**From:** [Bertha Gunawan](#)  
**To:** ["Operations Manager"](#); [Nasr Atie](#); [Noy Santiago](#); [danny@planningdirection.com.au](mailto:danny@planningdirection.com.au)  
**Cc:** [Judith Portelli](#); [Alan Middlemiss](#)  
**Subject:** HPE CM: RE: HPE CM: RE: Electronic Determination - 2017SWC068 - Blacktown - DA17-00007, Address - 59 Cudgegong Rd, Rouse Hill  
**Date:** Thursday, 26 September 2019 12:11:20 PM  
**Attachments:** [image005.png](#)  
[image006.png](#)  
[image002.png](#)

2017SWC068 - Blacktown – DA17-00007

Address – 59 Cudgegong Rd, Rouse Hill, Proposed Lot 1 in subdivision of Lot 74 DP208203

Description – Construction of 2 x 8 storey residential flat buildings comprising 163 apartments,  
229 car parking spaces in 2 basement levels and associated civil and landscaping works.

***Approved development at No 65 Cudgegong Road  
- approved eastern allotment upper basement level***

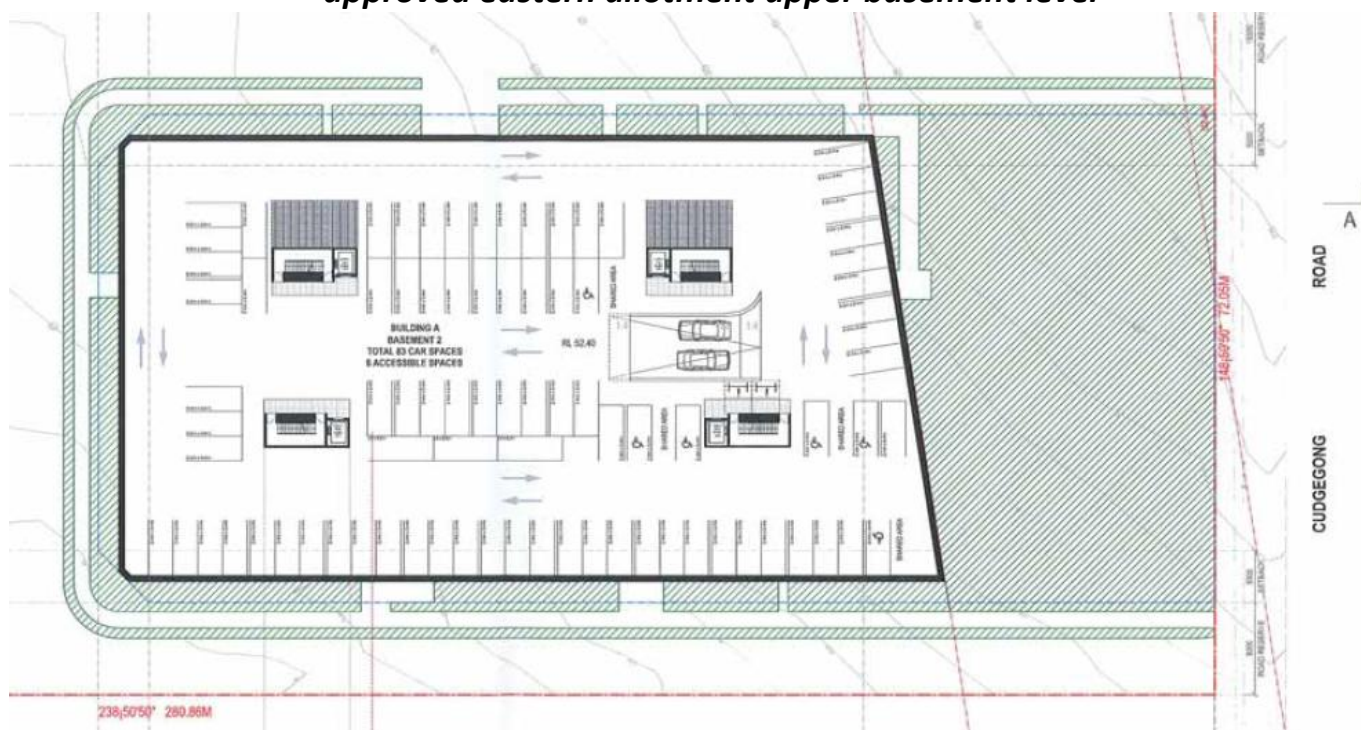
In respect of the ‘eastern’ allotment No 65 Cudgegong Road the following matters are noted:

- The basement on the ‘eastern’ allotment is setback 2m from the property boundaries – the setback areas to the street frontages do not satisfy the 6m dimension requirement for inclusion in the deep soil calculation.

- The small centrally located landscaped ‘pocket’ on the ‘eastern’ site depicted on the upper basement level does not extend through the lower basement level and is thus not deep soil (rather it is ‘planting on structures’). Further this area has a dimension of less than 6m. The ‘pocket’ does not satisfy the requirements to be included in the deep soil calculation.

- Other than the 2m street setbacks, and the area of the transmission line easement the two basement levels on the ‘eastern’ allotment covered the entire site. The only part of the ‘eastern’ allotment that was deep soil (having a dimension of 6m or more and not being ‘planting on structures’) was in fact the area of the easement.

***Approved development at No 65 Cudgegong Road  
- approved western allotment upper basement level***

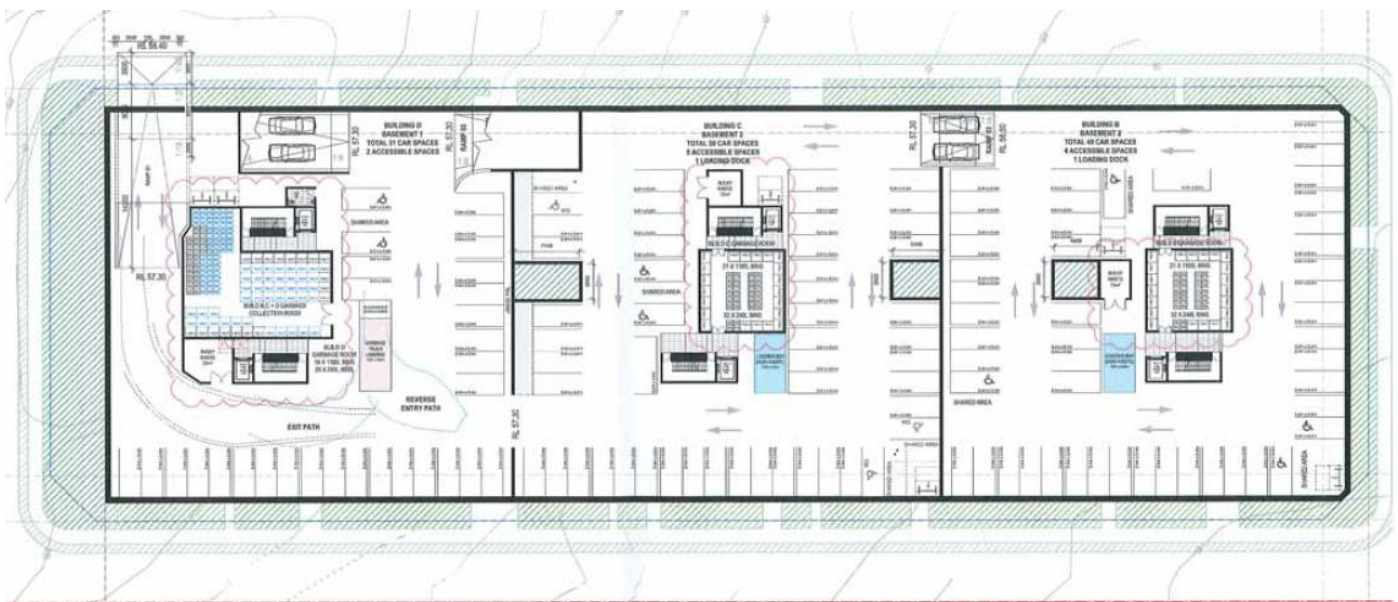
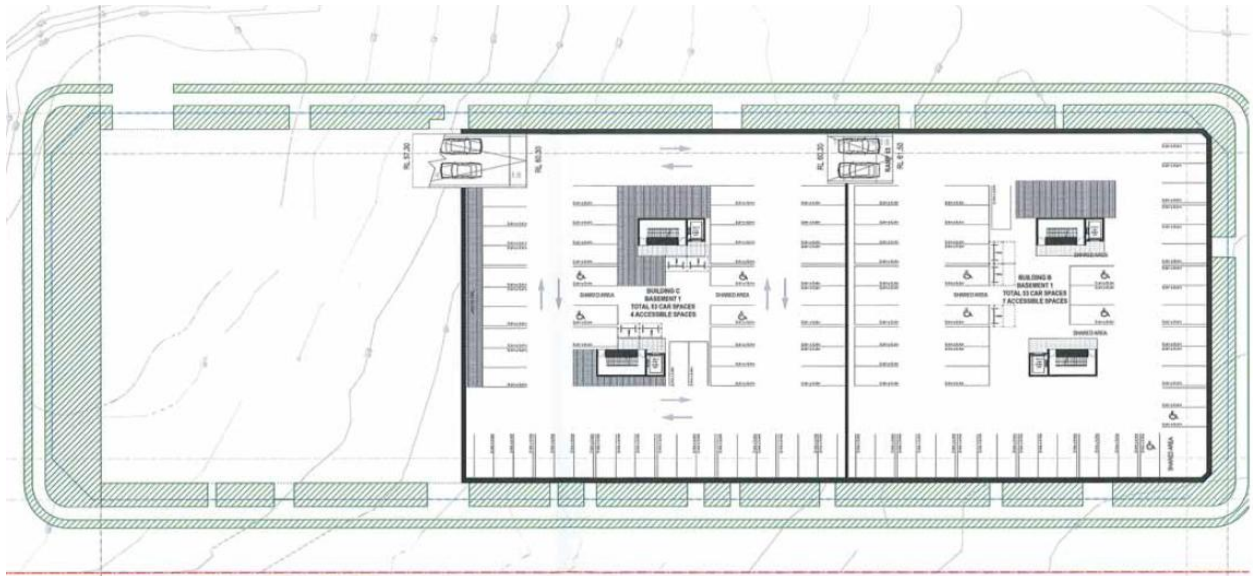
In respect of the 'western' allotment No 65 Cudgegong Road the following matters are noted:

- The basement on the 'western' allotment is setback 2m from the property boundaries – the setback areas to the street frontages do not satisfy the 6m dimension requirement for inclusion in the deep soil calculation.

- The basement covers the entire allotment other than the 2m street setbacks and a wider deep soil strip to the western street frontage.
- The internal landscaped 'pockets' shown on the approved basement plans do not extend through both basement levels and are thus are not deep soil, rather they are 'planting on structures'. Further these pocket areas have a dimension of less than 6m. The pockets do not satisfy the requirements to be included in the deep soil calculation.

- The only part of the 'western' allotment that was deep soil (having a dimension of 6m or more and not being 'planting on structures') was in fact the strip of land adjacent to the western road frontage.

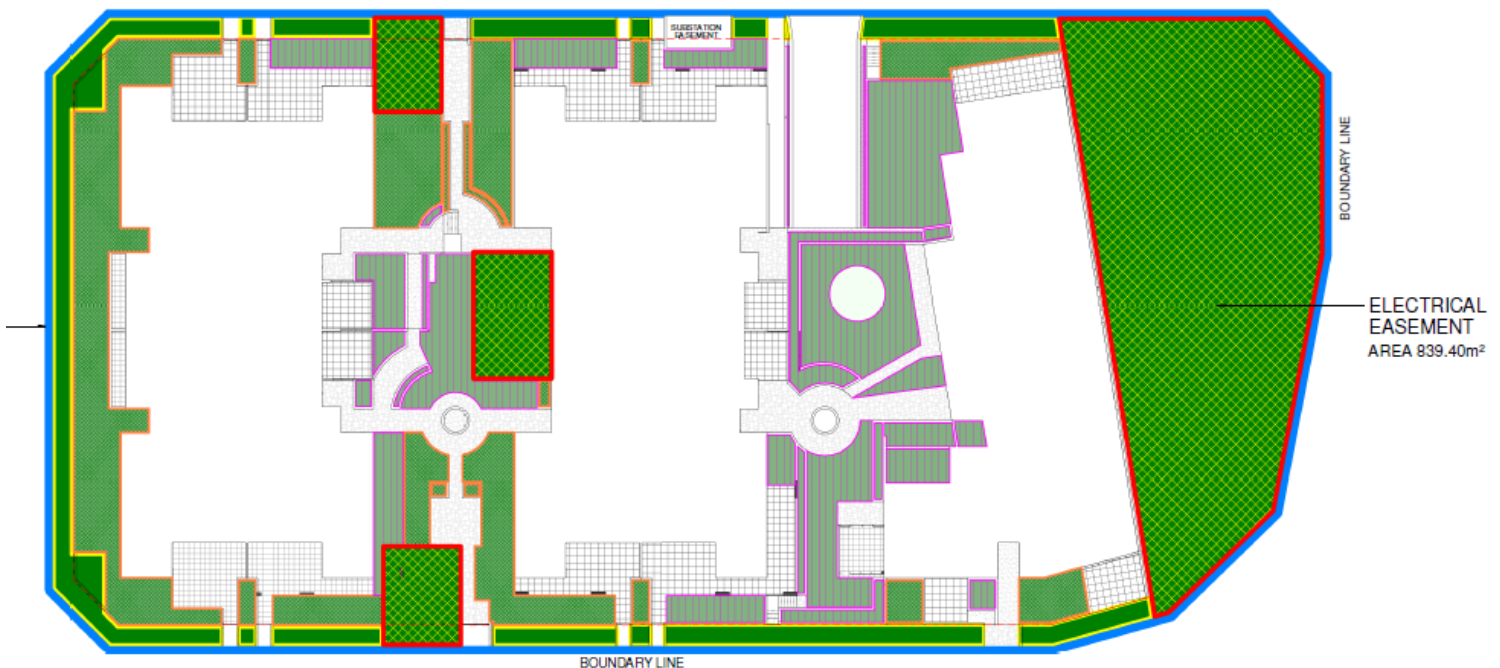
1. For the purpose of resolving the panel's concern on deep soil zone provision, it is noted that the proposed development area outside the electrical easement area is 4,836m<sup>2</sup>. Therefore, the Apartment Design Guide (ADG) requires that a minimum deep soil area of 725m<sup>2</sup> (15% of the development area and having the minimum dimensions of 6m x 6m) shall be provided on the site. The proposed deep soil increase as shown in the amended plans, provides only a total of 175m<sup>2</sup> of deep soil area within the development area, or 3.6%. Together with the proposed deep soil area not complying with the minimum 6m x 6m dimensions (but capable for canopy trees as indicated in your landscape plan), the overall total deep soil provision is 589m<sup>2</sup>, which is still 136m<sup>2</sup> under the minimum requirement of the ADG.

Based on the above findings, I highly doubt that the Panel is going to be satisfied with your current response and could just proceed to refuse the DA and we do not want this to happen. On this basis we strongly recommend that you urgently consider an additional reduction of at least 10 car parking spaces on basement level 1 or approximately additional deep soil area of 160m<sup>2</sup> that is complying with the 6m x 6m dimensions as required by the ADG.

This amount, together with the overall 589m<sup>2</sup> of deep soil area already proposed on the plans, even though it does not strictly comply with the minimum 6m x 6m dimensions, will numerically achieve the 15% requirement.

- The applicant has undertaken further amendments to increase deep soil and reduce on site car parking as requested by the Panel.

- The deep soil provision under the amended proposal more than complies with the deep soil requirements of the ADG well exceeding the 7% standard and more exceeding the 15% guideline. The calculations are as follows.

**Site area: 5,674.9sqm**

**Provided deep soil with a dimension of greater than 6m - 1,017sqm or 17.9% of the site area.**

**Additional deep soil with a dimension of less than 6m (essentially being the street setbacks): 384sqm or 6.77% of the site area**

**Additional planting on structures (soil depth 1m or more): 537sqm or 9.46% of the site area.**
